**SUBJECT: BROOKHAVEN NATIONAL LABORATORY REMEDIAL DESIGN  
IMPLEMENTATION REPORT – DIFFERENCES IN THE SCOPE OF REMOVAL  
OF THE BROOKHAVEN GRAPHITE RESEARCH REACTOR (BGRR)  
BIOLOGICAL SHIELD, DECEMBER 21, 2011**

## **Remedial Design Implementation Report**

Differences in the Scope of Removal of the Brookhaven Graphite  
Research Reactor (BGRR) Biological Shield

**COMMENT RESOLUTION FORM**  
**REMEDIAL DESIGN IMPLEMENTATION REPORT (TECHNICAL WHITE PAPER)**  
December 2011

**Figure 2**  
**Section View of Biological Shield during Removal Activities**

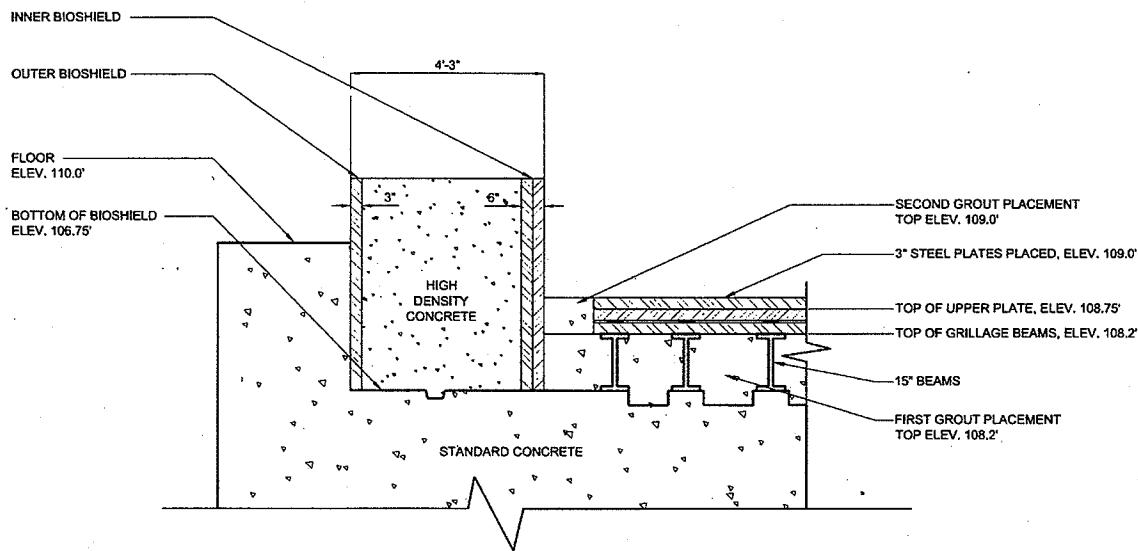
In preparation for the removal of the biological shield, 3-inch thick steel plates were placed over the upper pile bedplates to reduce the radiological dose to the workers who would be exposed during the setup and operation of the torch-cutting and concrete breaking equipment. These steel plates were secured in place with a concrete grout similar to that used in grouting the intake plenums. The elevation on the upper surface of these steel plates and the grout is elevation 109'-0" (Figure 2).

**Figure 3**  
**Section View of Proposed End State**  
**(Typical for North, West & South Walls)**

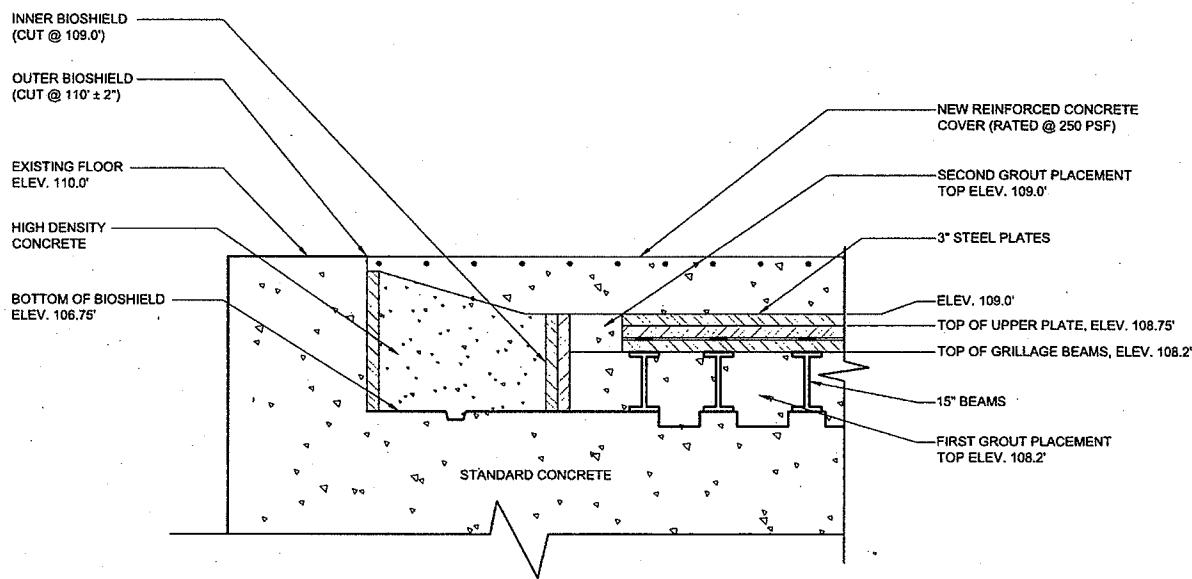
- Biological Shield Foundation below Floor Elevation (Figure 3):** Removal of the biological shield inner steel wall and concrete structure will take place to the Building 701 floor level (elevation 110'-0"). The outer steel walls which are free of radiological activation will also be removed to elevation 110'-0". The remaining portion of the bioshield foundation below the building floor will be protected beneath a reinforced concrete cover. The steel plates that were placed over the pile bedplates and cementitious grout installed during the removal activities will also remain in place beneath the reinforced concrete cover. This will provide for a structurally stable long-term configuration,

with no void spaces, no pathway to groundwater for radioactive contaminants, and radiological dose rates not exceeding 0.1 milliRem per hour (mR/hr). The remaining portion of the bioshield wall will also be documented in an Explanation of Significant Differences document. This ESD, titled Area of Concern 9 Brookhaven Graphite Research Reactor, Explanation of Significant Differences for the Biological Shield Removal (Ref. 4) is prepared for DOE by BSA.
